Service Bulletin

AUGUST

NO. 327

SOUTH BEND 27, INDIANA

Fig. 1

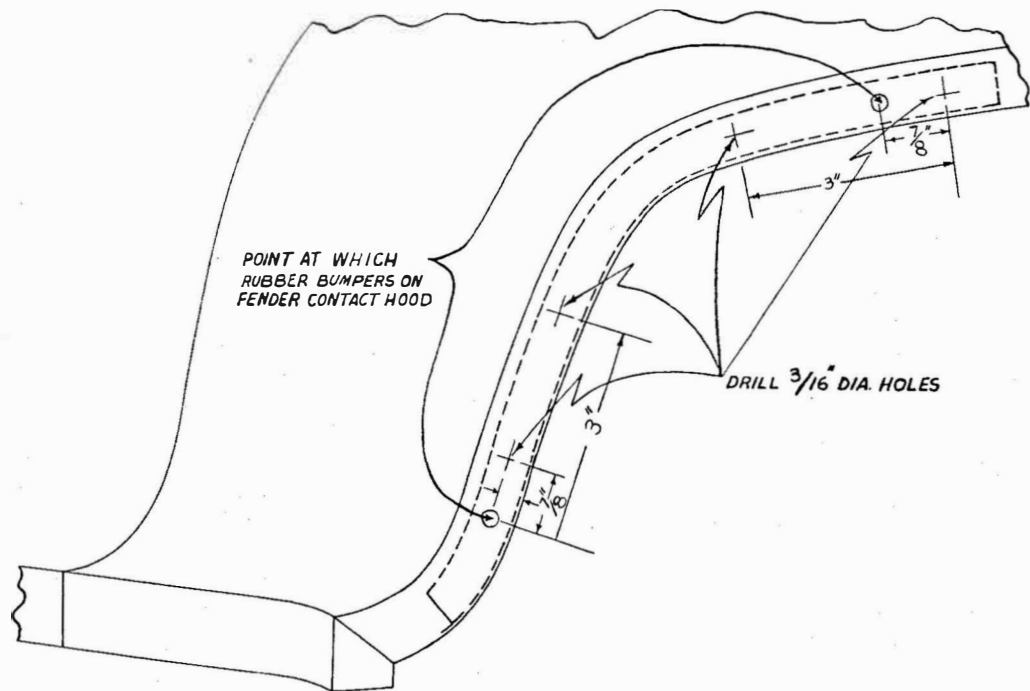
Reinforcements are now being added in production to the hoods of all sedans and station wagons. A reinforcement is located in each side flange near the front corner. Although the reinforcements are being welded in production, they may be installed in the field by using small bolts and nuts. However, a flat oval-head bolt must be used to prevent interference at the fender when the hood is closed.

Layout and center-punch the hole locations

on the hood flange to the dimensions shown in Fig. 1. Then, drill the holes with a 3/16" diameter drill. The bracket may be held in position on the flange with lock-type pliers and, the flange and bracket drilled at the same time. After installation of the bracket, check the clearance between the bolt heads and the fender. Provide clearance if necessary, by carefully striking the head of the bolt with a rubber mallet.

- 1 - 1320686 Bracket, right
- 1 - 1320687 Bracket, left
- 8 - 2055X1 Bolts
- 8 - G271166 Nuts

After completing the installation, paint the brackets.
